FINAL REPORT

Review of VMT Tank Inspection Timelines

William Mott P.E.

Figure 1 – 2025 APSC Tank 5 Corrosion Rate Calculation

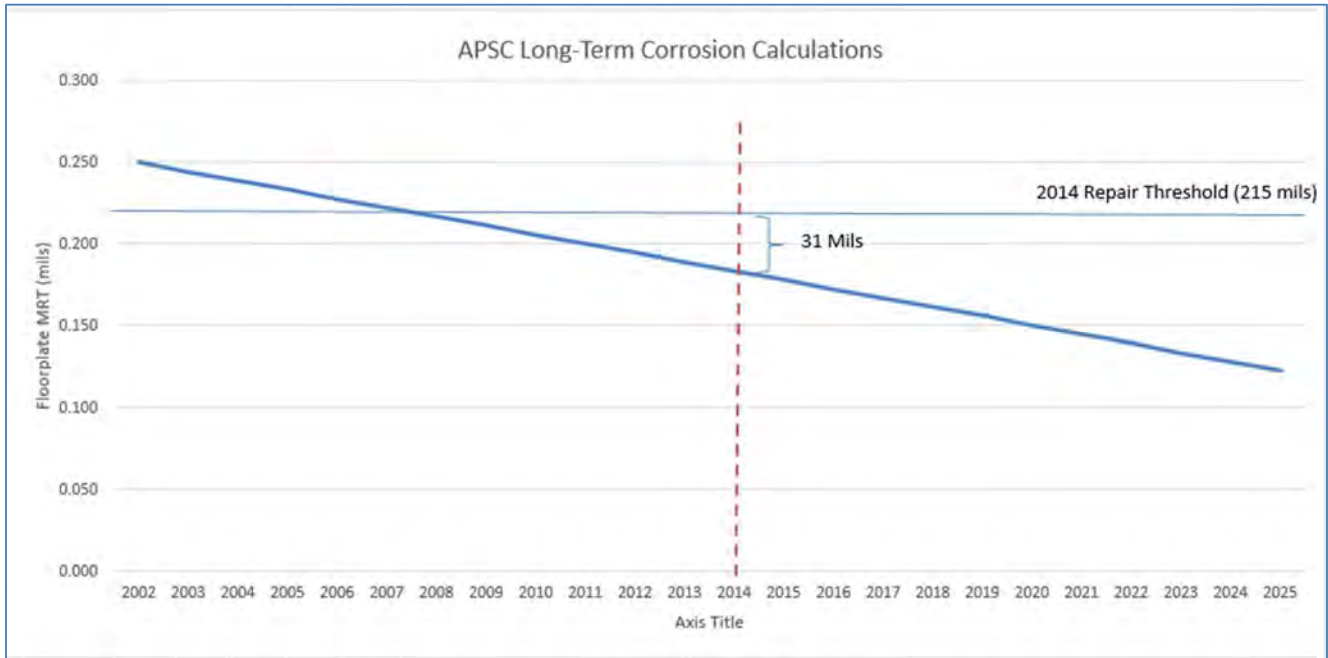
Figure 1 graphically depicts the long-term corrosion rate calculated in the Tank 5 2025 Engineering Summary Report. The issue is that based on the assumptions and logic behind the long-term calculations, the deepest pit discovered in 2025 (0.123-inches MRT) would have had a wall thickness of 184 mils in 2014 if it had been subjected to a corrosion rate of 5.5 mpy. That MRT is well below (31-mils below) the 2014 repair threshold. **This indicates that either the corrosion rates accelerated between 2014 and 2025 or the 2014 inspection missed a 184 mil RWT pit.**

My professional opinion is that the long-term corrosion rate calculations are invalid. They result in artificially reduced predictive corrosion rates.

The 2025 Engineering Summary Report used the 5.5 mpy long-term corrosion rate that they calculated, coupled with a repair threshold of 0.210-, to calculate a service interval of 20-years, suggesting that the next out-of-service inspection should take place in 2045.

Taku Engineering used the 2014 repair threshold of 0.215 mils, the 2025 MRT of 0.123-inches, and a service interval of 11-years (2014-2025) to calculate a short-term corrosion rate of 8.36 between 2014 and 2025. Taku's short-term corrosion rate calculations are shown graphically in Figure 2.

Using the 2014-2025 corrosion rate of 8.36 mpy, and the 2025 repair threshold of 0.210-inches, Taku calculated a service interval of 13-years before the next out-of-service inspection. Tank 5 should be removed from service for an internal inspection in 2038.

Figure 2 – Taku Short-Term Corrosion Rate Calculations for Tank 5

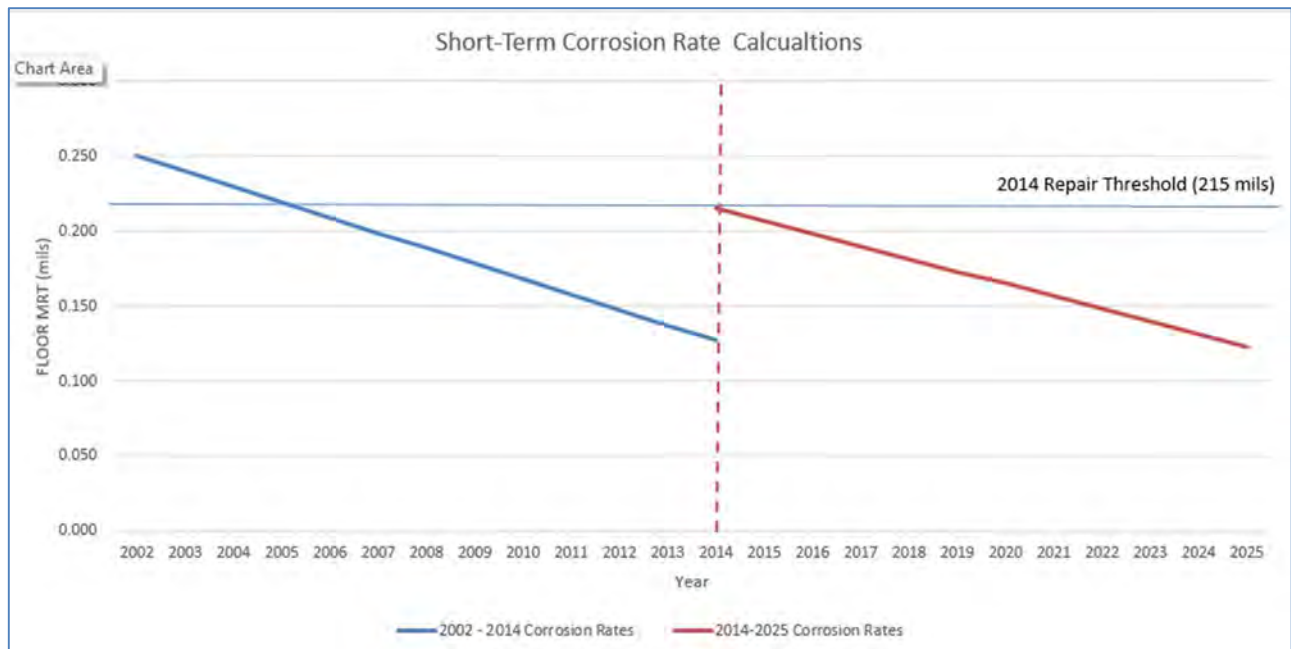
Taku's calculations assume that the deepest pit discovered in 2025 was at the repair threshold in 2014; it may have been thicker. That means that the corrosion rate between 2014 and 2025 was 8.36 mpy or greater.

- Remove Tank 5 for the next out-of-service inspection in 2038 not 2045 as recommended in the 2025 Tank 5 Engineering Summary Report.
- Update the ODPCT to reflect a 2038 inspection for Tank 5.

Figure 3 – 2013 APSC Tank 80 Corrosion Rate Calculations

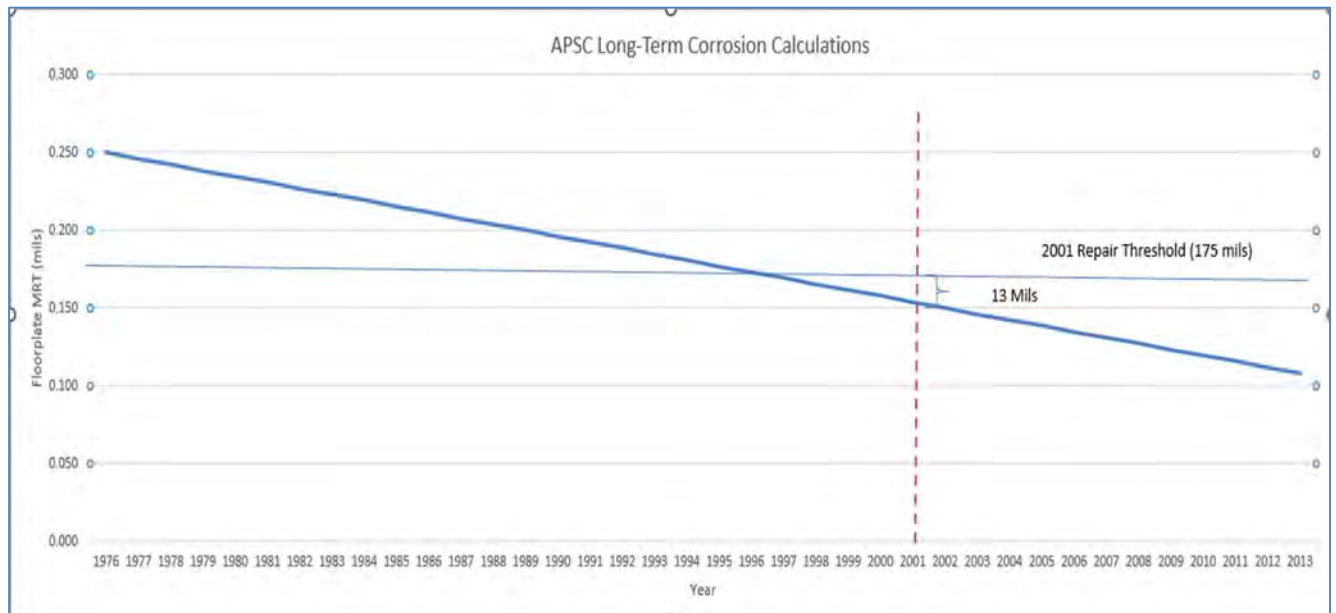
Figure 3 graphically depicts corrosion rate calculated in the Tank 80 2013 Engineering Corrosion Report. The issue is that based on the assumptions and logic behind the long-term calculations, the deepest pit discovered in 2013 (0.120-inches MRT) would have had a wall thickness of 162 mils in 2001. That MRT is below (13-mils below) the 2001 repair threshold of 175 mils. **This means that either the corrosion rates accelerated between 2001 and 2013, the 2001 inspection missed a 162 mil RWT pit, or the use of a long-term corrosion rate is invalid in this situation.**

Alyeska used the 3.84 mpy long-term corrosion rate that they calculated, coupled with a 2013 repair threshold of 0.178-inches, to calculate a service interval of 20-years, suggesting that the next out-of-service inspection should take place in 2033.

Taku Engineering used the deepest pit found in 2013 (0.108-inches remaining), the repair threshold in 2001 (0.175-inches), and the service interval between inspections (12-years) to calculate a short-term (2001-2013) corrosion rate of 5.58 mpy. Taku's calculations assume that the deepest pit discovered in 2013 was at the repair threshold in 2001; it may have been thicker. That means that the corrosion rate

Using the 2001-2013 corrosion rate of 5.58 mpy, and the 2013 repair threshold of 0.178-inches, Taku calculated a service interval of 14-years before the next out-of-service inspection. Tank 80 should be removed from service for an internal inspection in 2027.

Figure 4 – Taku Short-Term Corrosion Rate Calculations for Tank 80

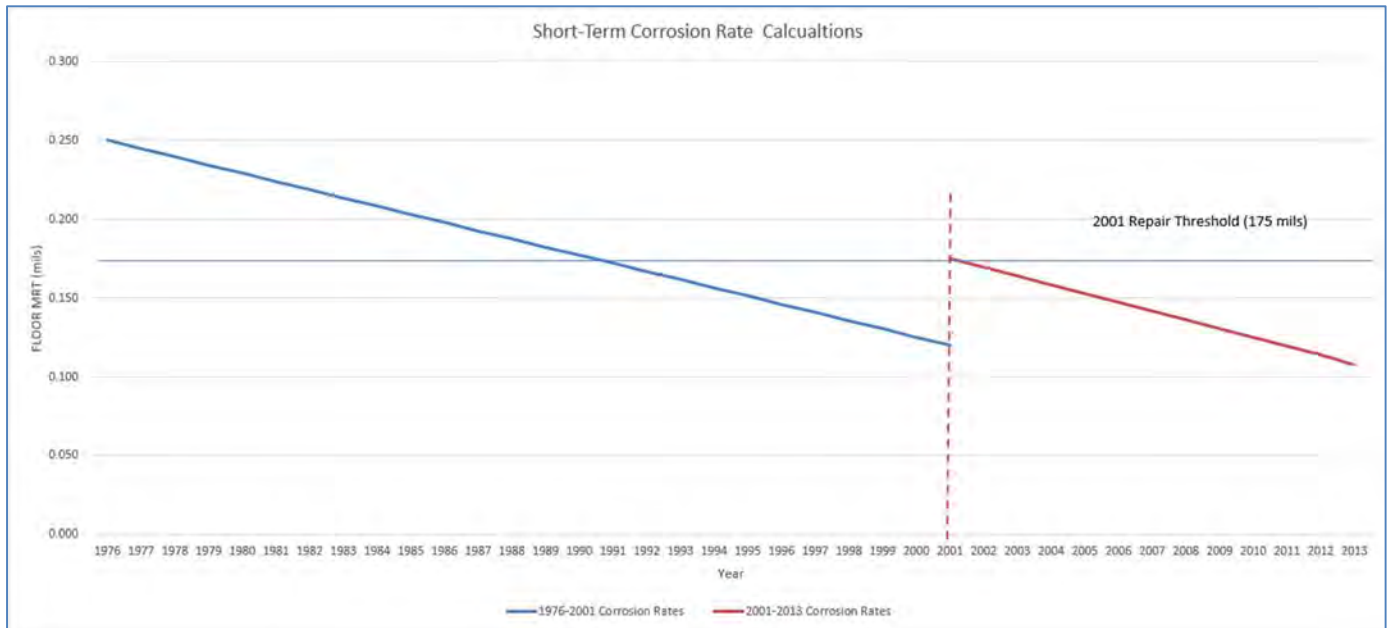
between 2001 and 2013 was 5.58 mpy *or greater*, not 3.84 mpy as the long-term calculations suggest. Taku's short-term corrosion rate calculations are shown graphically in Figure 4.

- Remove Tank 80 for the next out-of-service inspection in 2026, not 2033 as recommended in the 2013 Tank 80 Engineering Corrosion Report.
- Update the ODPCP to reflect a 2027 inspection for Tank 80.
